Peg Development 19-096-Bus Turn Exhibit

### Memo: Additional Traffic Information, Response to AECOM Comments (03/22/2021)

Clarified points made in 03/18/2021 review of traffic items by AECOM. Key takeaways:

DAY SKIER DROPOFF ENLARGEMENT

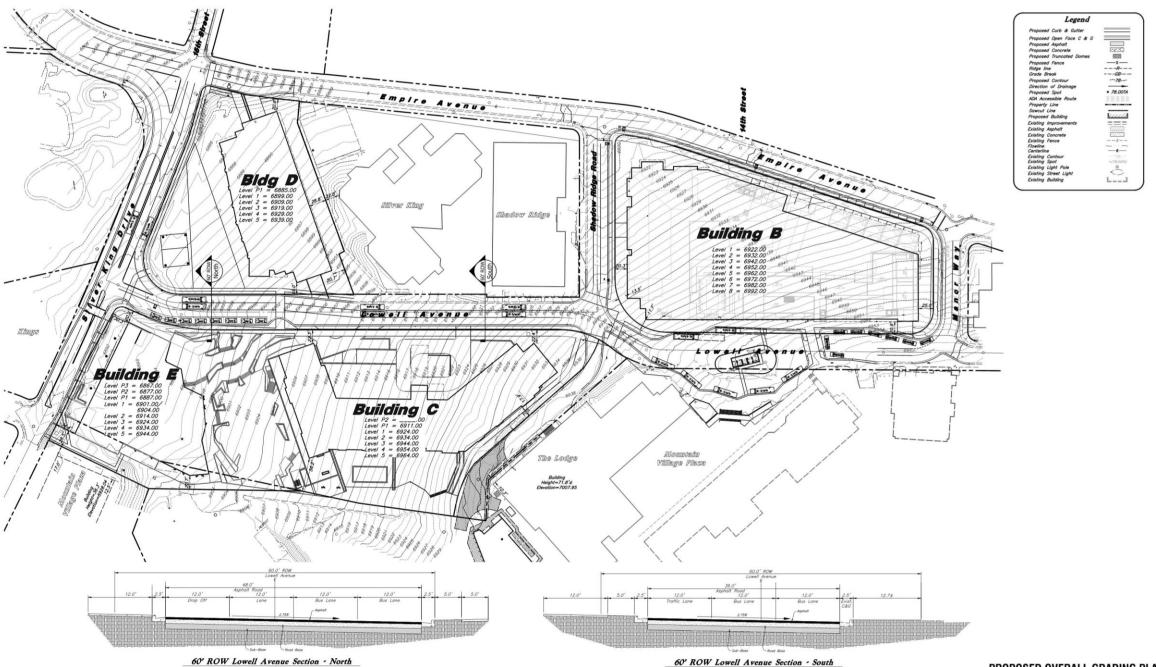
- Enhance the pedestrian experience with in the transit center using different materials, lighting, landscaping, Etc. To take place at CUP phase.
- Provide additional capacity for day skier drop off.
- Work with AECOM and city staff to incorporate recommended details to 2B transit center.
- Consider innovative uses for unused nonpeak parking stalls.
- Implement measures to discourage traffic on residential streets using signage and way finding.

### Loading Area

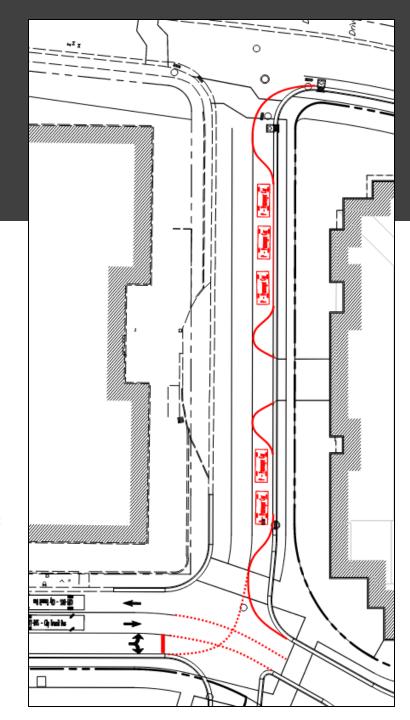
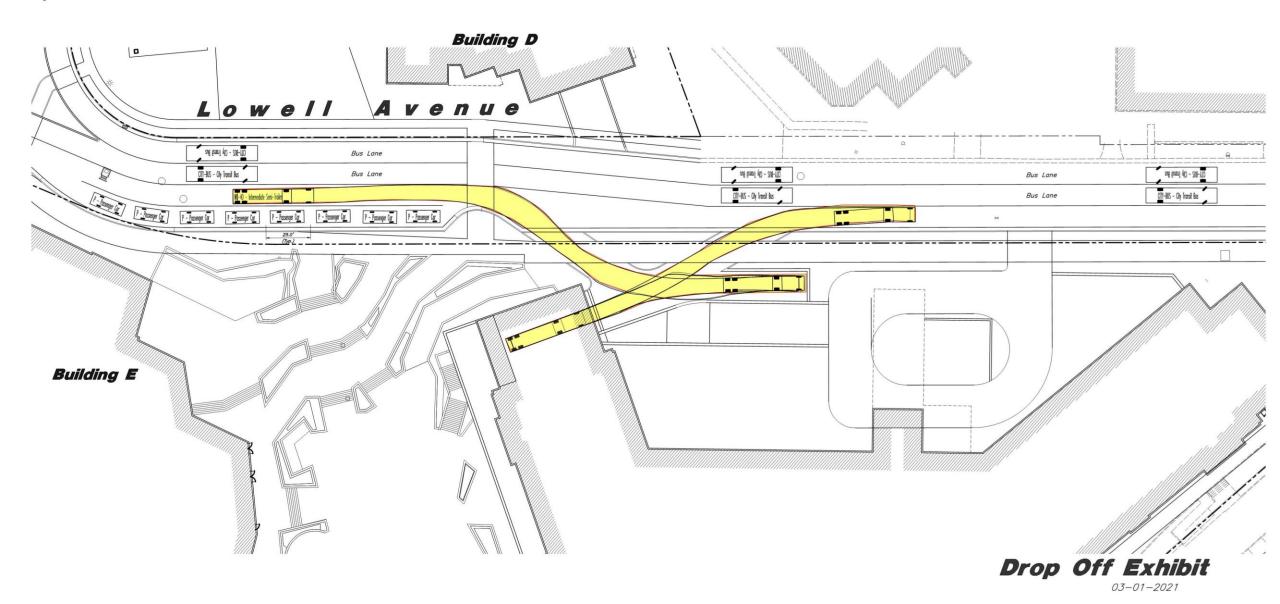
The City raised concerns about sufficient loading area for passenger vehicles

Additional loading areas for pick-ups and drop-offs can be provided on Shadow Ridge Road, providing space for 5 additional vehicles

Overflow loading areas may also be allocated in excess parking areas in the garages

AECOM stated in their review that they agree with the general drop-off plan that has been presented

## Pedestrian Level of Service

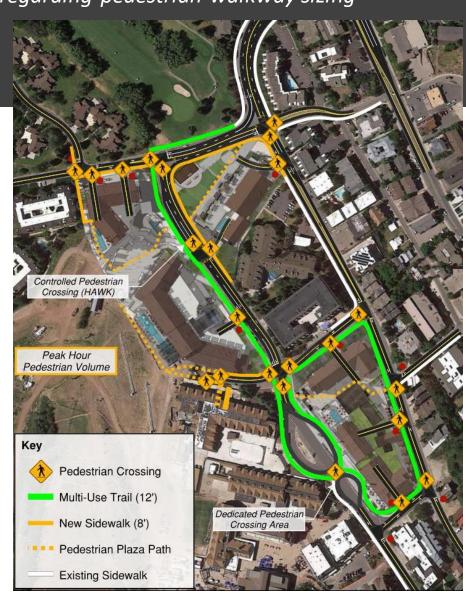
The City has raised concerns regarding pedestrian walkway sizing

- Peak of 1,200 pedestrians per hour anticipated near Parcel B
- Highway Capacity Manual outlines level of service (LOS) for sidewalks and walkways
- For a 12-foot path, 1,200 pedestrians in an hour would represent LOS B
- The LOS C capacity (acceptable) of a 12-foot path is 4,320 pedestrians in 1 hour, or 3.6 times the anticipated demand

#### Mid-block pedestrian crosswalk on Lowell:

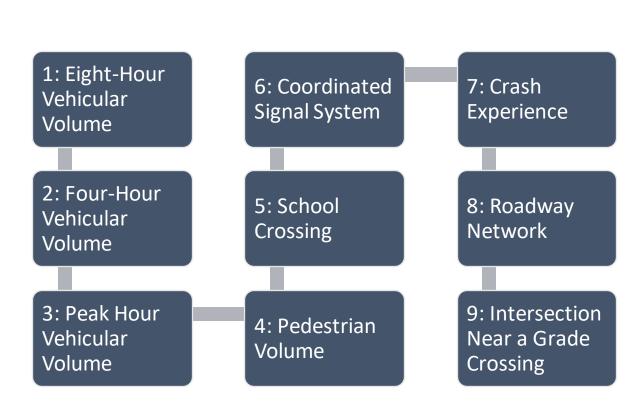
- AECOM: recommended moving crosswalk to the north
- This will result in less pick-up / drop-off space
